Response to the request for review for the CDM project activity

"Jiangxi Pinggang Group 20MW Waste Gas and Surplus Steam based Captive Power Plant" (Ref. no. 2499)

Please find below the response to request for review formulated for the CDM project with the registration number 2499.

Figure 1 Historical percentages of waste BFG and other categories of BFG consumptions from 2004 to 2008 (project scenario).

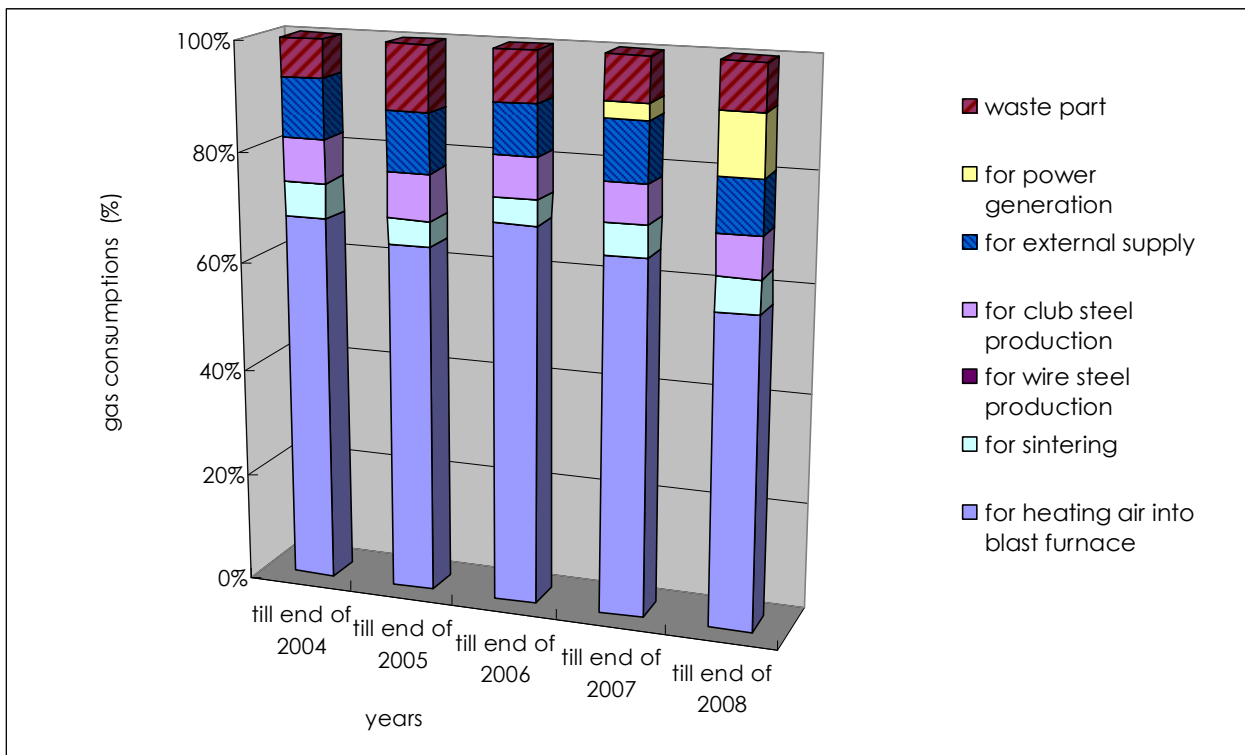
The DOE shall further substantiate elimination of alternative; waste gas/heat is sold as an energy source as waste gas is sold in the pre-project scenario.

To further demonstrate that, a significant and noticeable fact is that there was still part of BFG left in surplus after operation of project activity. (For details, please refer to Figure 1 and Figure 2).

In Figure 1, it shows the varying percentages of each use of BFG and the waste part from 2004 to 2008. According to this chart, it can be found that amount of external supply has been kept in a stabilized level and was never impacted by the project activity. In addition, there was still considerable amount of waste BFG remained after operation of the project, as shown by the red block at the top row. Therefore, the availability of waste BFG in the pre-project scenario can be justified.

In addition, although the BFG for heating air into blast furnace seems decreased in 2008, the ratio falls in a reasonable range according to the FSR of blast furnace, and the reason of this decline is due to the operation optimization of blast furnace.

- i. In year 2005 the waste BFG was $319,381,853 \text{ Nm}^3$, whereas the BFG consumed in project activity in 2008 is $317,188,349 \text{ Nm}^3$. therefore the quantity of BFG used in project activity did not exceed the maximum value in the past three years. In that case, the fcap value is more than 1, which means all the BFG used in project activity was form the waste part in pre-project scenario. Furthermore, the decrease of BFG used for air heating is not resulted by the project activity clearly.

- ii. In year 2005 the ratio of BFG for air heating was about 65%, but this value drop to 55% in year 2008. The reduction of BFG for air heating is caused by operation optimization to reach the designed working condition of blast furnace. According to FSR of the blast furnace, the designed BFG consumption of air heating furnace is $52260 \text{ Nm}^3/\text{h}$, while the total BFG amount ranges form $97000 \text{ Nm}^3/\text{h}$ to $130000 \text{ Nm}^3/\text{h}$. therefore, the current ratio 55% has fallen in a reasonable range according the designed value, after a gradual optimizations.
